STAFF RECOMMENDATION

**1621 Forrest Avenue
December 20, 2017**

Application: New construction-infill

Description of Project: The applicant proposes to construct a new one-story house with a cross-gabled roof, matching the size and bungalow form of an historic house that previously stood on the lot.

1621 Forrest Avenue, after a fire in the summer of 2017.

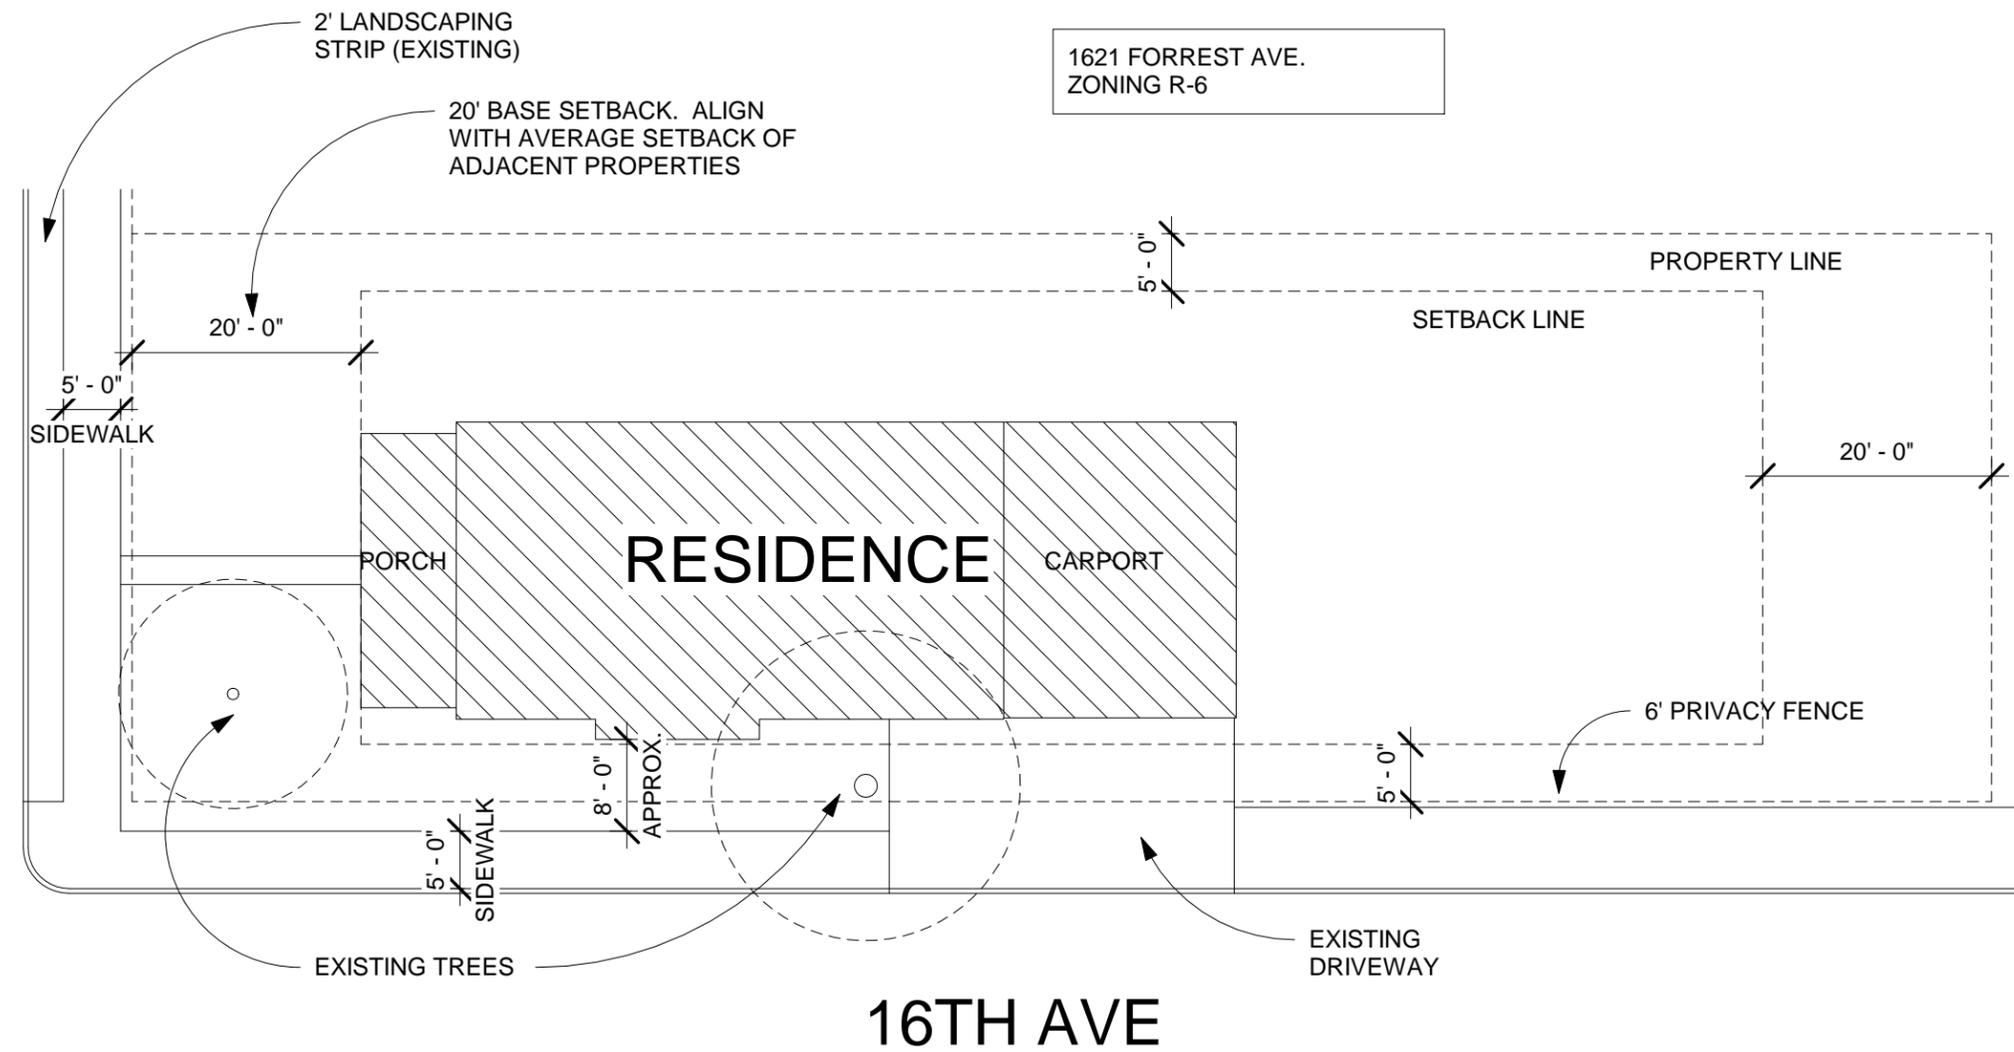
View of house after demolition, showing concrete porch slab and brick chimney, both of which are to be re-used in the new house.

View from North 17th Street showing foundation and rear porch/carport, both of which are to be reused in the new house.

1 SITE PLAN
1/16" = 1'-0"

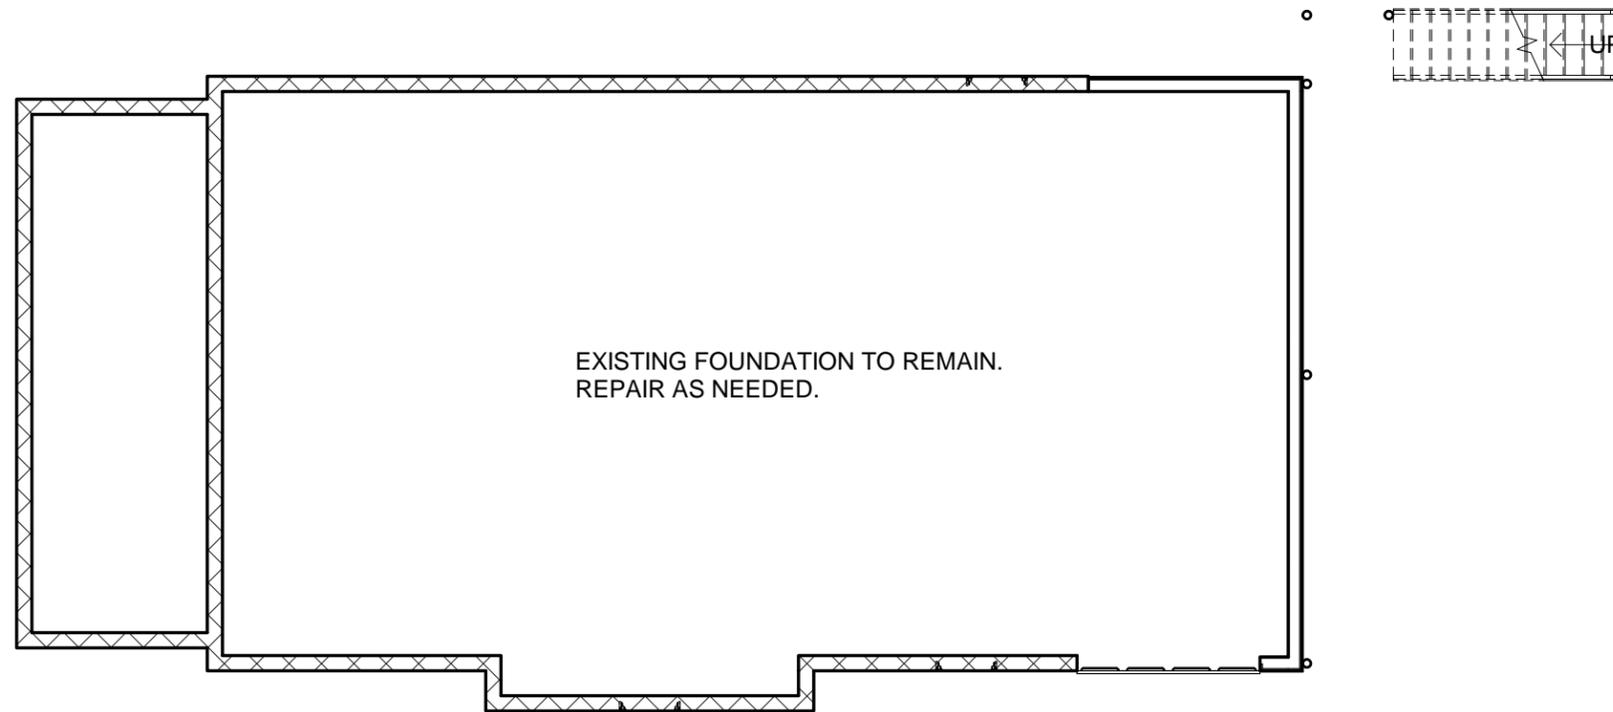
Setback & Rhythm of Spacing: The footprint of the new house will match the previous one, in the same location. In fact, the applicant intends to reuse the foundation from the recently demolished house. The front setback of will match the previous house, as will the left and right setbacks of sixteen feet and thirteen feet (16' and 13'), respectively. These setbacks are compatible with the setbacks of the surrounding historic context and meet section II.B.3 of the design guidelines.

Orientation: The primary facade of the new house will face Forrest Avenue directly, in the same direction and manner as the previous structure and other historic buildings on the block. There is an existing paved walkway connecting the porch to the Forrest Avenue that is to be retained. The right side of the house, facing North 17th Street, will have a basement level garage facing the street, as there was on the previous house. Staff finds that the orientation of the project meets section II.B.6 of the design guidelines.

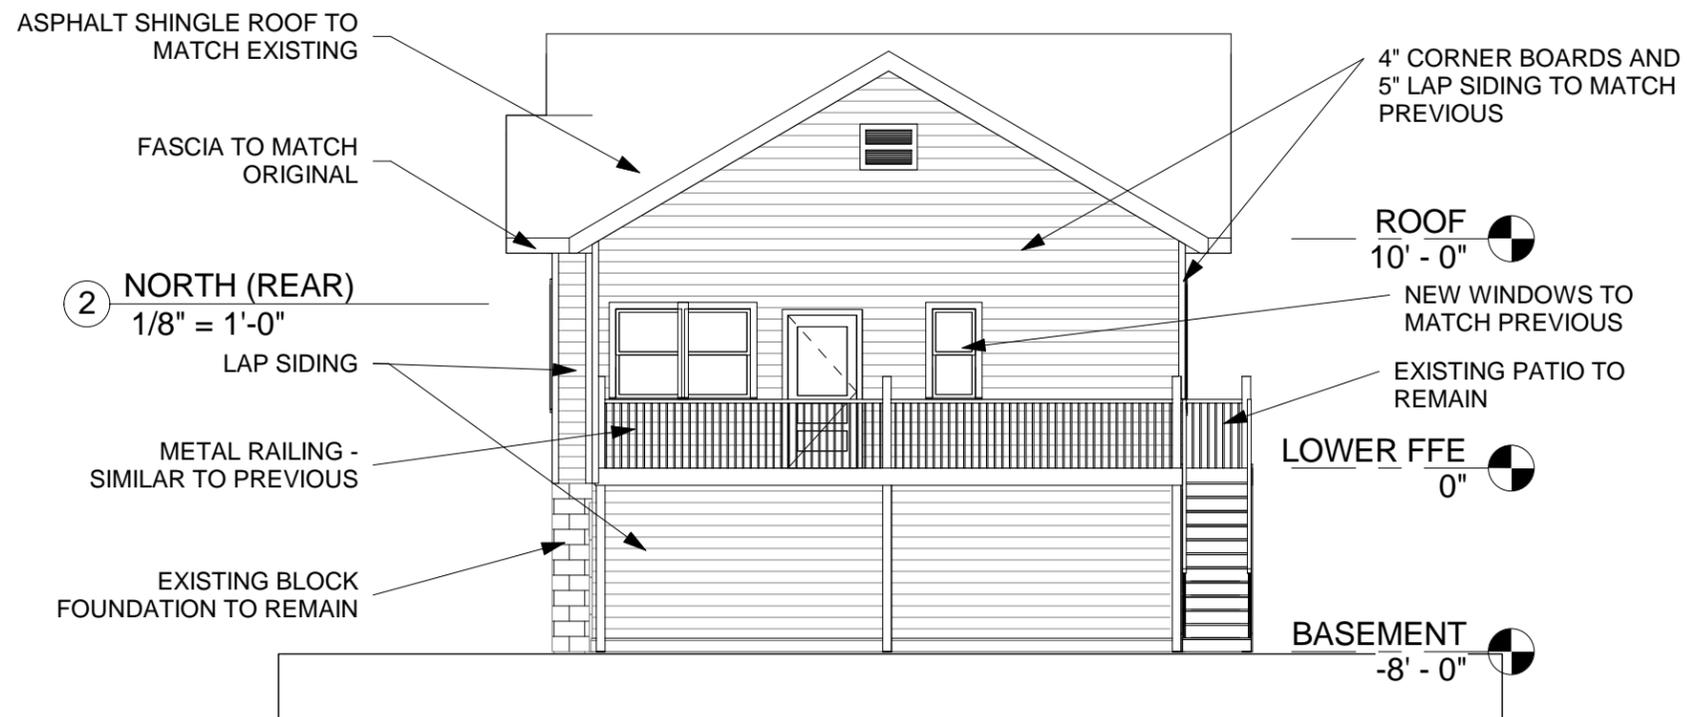
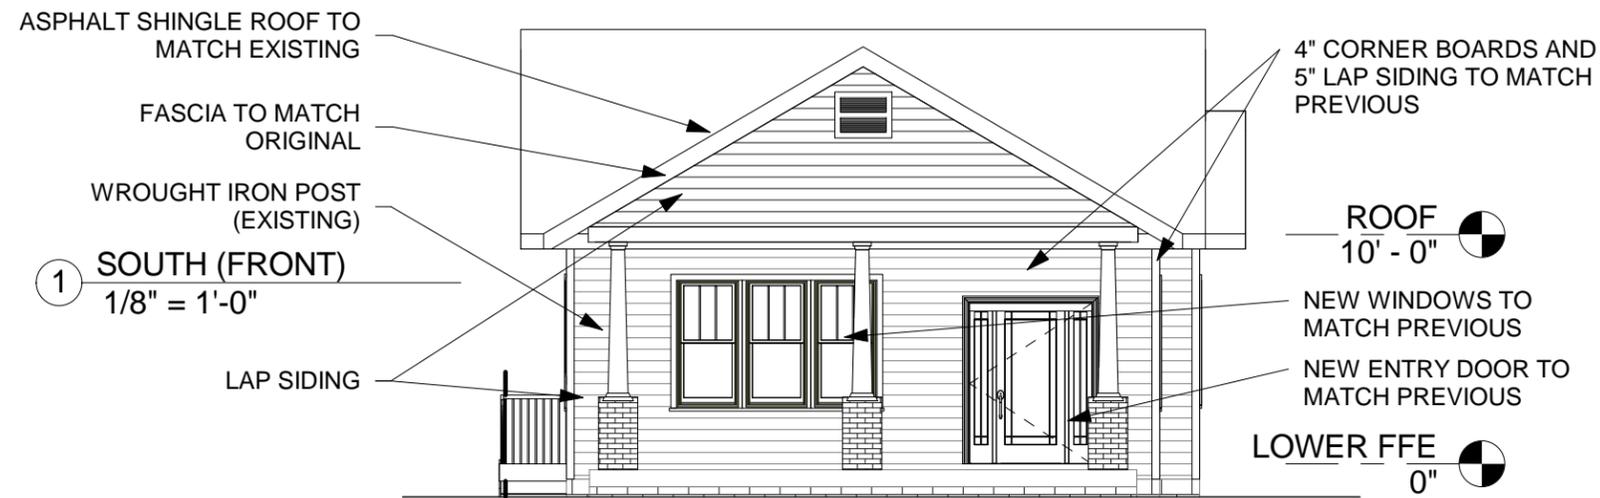
Height & Scale: The new house will have a side-gabled bungalow form with projecting front-gabled porch and a rear-gabled wing. The house will have a roof height of nineteen feet (19") above the floor level with an eave height of nine feet, above an exposed foundation approximately two feet (2') tall at the front. Due to a drop in grade, an additional six feet (6') of foundation will be visible at the rear. These heights match the heights of the previous historic house, and are compatible with other surrounding historic houses.

Proportion and Rhythm of Openings: The windows on the proposed new house will match the locations and proportions of openings on the previous structure. The windows will be double hung, most will have divided light sashes with others having single-light sashes, matching the windows on the previous structure. The house will have a street-facing garage in the basement level on the right side. Although not very common, this will match the condition of the previous historic house that was on the lot. For this reason and because the proportion and rhythm of openings on the new building are generally compatible with historic houses, Staff finds that the new house will meet section II.B.7 of the design guidelines.

Recommendation: Staff recommends approval of the proposed new house, with the condition that window and door selections are approved by MHZC Staff prior to installation, finding that the proposal meets the design guidelines for new construction in the Lockeland Springs-East End Neighborhood Conservation Zoning Overlay.
